UNITED STATES PATENT AND TRADEMARK OFFICE

10/696,525

Office Action Summary

Figure 1 (Prior Art)

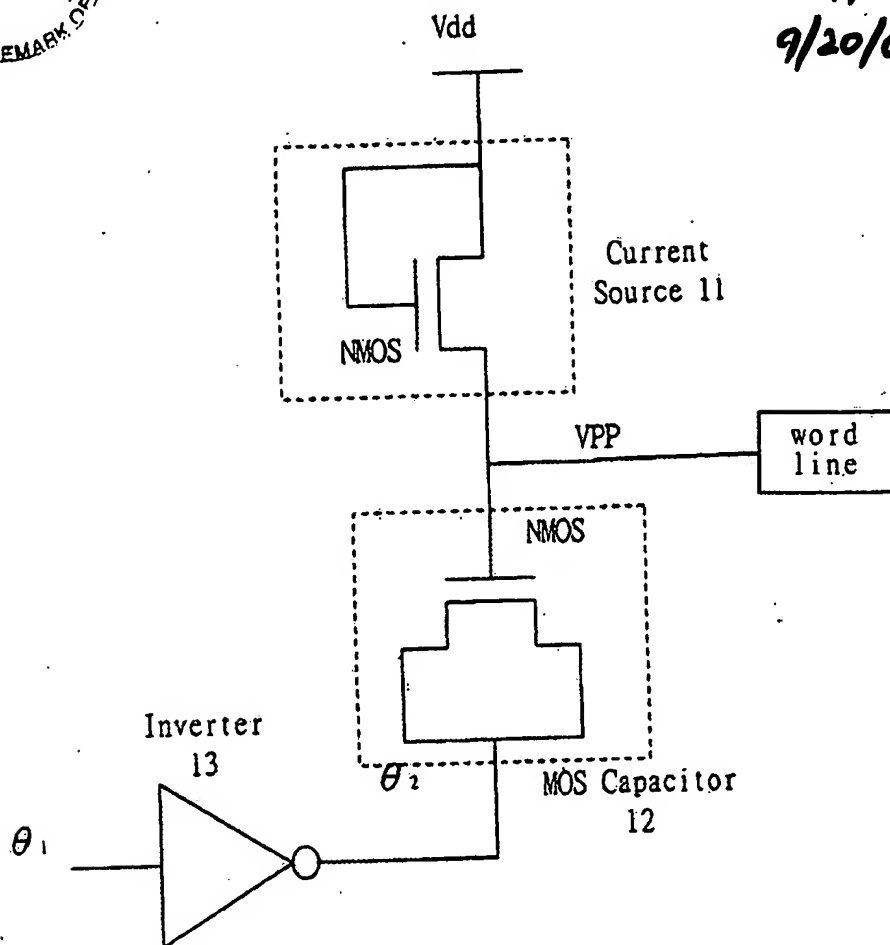
4. Claims 1-13 are, insofar as understood, rejected under 35 U.S.C. 103(a) as being unpatentable over Applicant's Fig. 1 Prior Art, in view of Selcuk et al., 5,879,980, and Hiratsuka et al., 5,453,707.

What is not shown in Applicant's Fig. 1 Prior Art is the storage cell.

It would have been obvious under 35 USC 103(a) to one of ordinary skill in the art at the time of the invention was made to serially connect a capacitor 40/42 in Fig. 1 of Selcuk et al., 5,879,980, between the output of inverter I3 and MOS capacitor 12 in Applicant's Fig. 1 Prior Art for the purpose of enhancing the capacitance to increase the stability and noise immunity of the memory cell (see lines 4-9, column 5 of Selcuk et al., 5,879,980).

What is not shown in Applicant's Fig. 1 Prior Art, which is modified by Selcuk et al., 5,879,980, is the driving circuit consists of a PMOS transistor and a NMOS transistor generating a first clock signal according to a second clock signal and a third clock signal.

It would have been obvious under 35 USC 103(a) to one of ordinary skill in the art at the time of the invention was made to utilize the CMOS inverter 18 in Figs. 4-5 of Hiratsuka et al., 5,453,707, for the inverter I3 in Applicant's Fig. 1 Prior Art, which is modified by Selcuk et al., 5,879,980, for the purpose of reducing power dissipation and preventing power source noise and ground noise (see lines 43-49, column 3 of Hiratsuka et al., 5,453,707).

Figure 2(A)

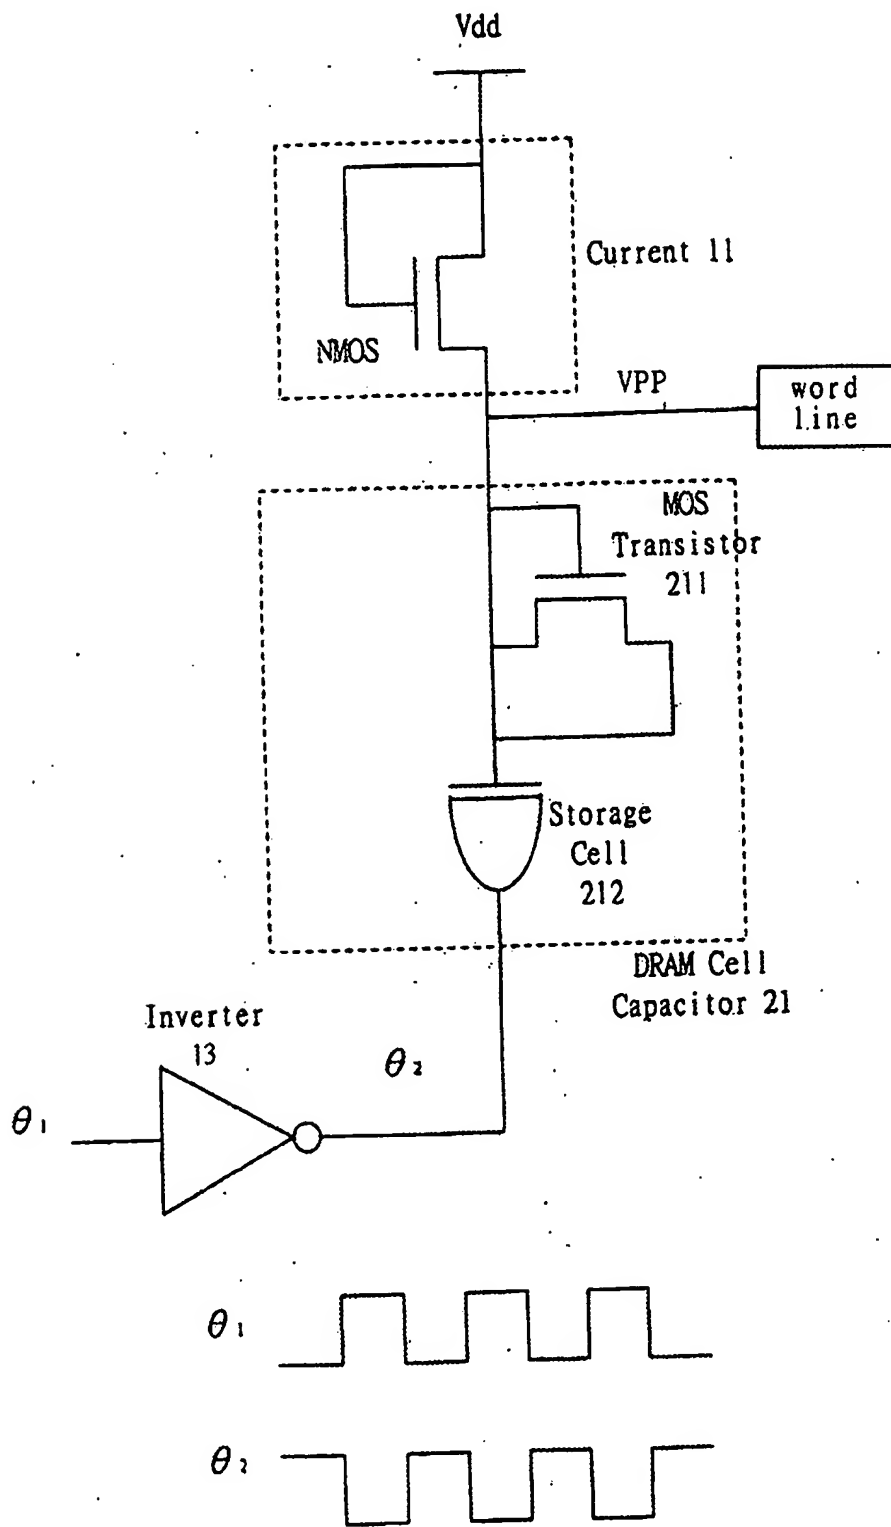
It is not understood what type of storage cell 212 in Figs. 2(A) and 2(B) really is. Is it whether a memory cell, a capacitor, a transistor or what else?
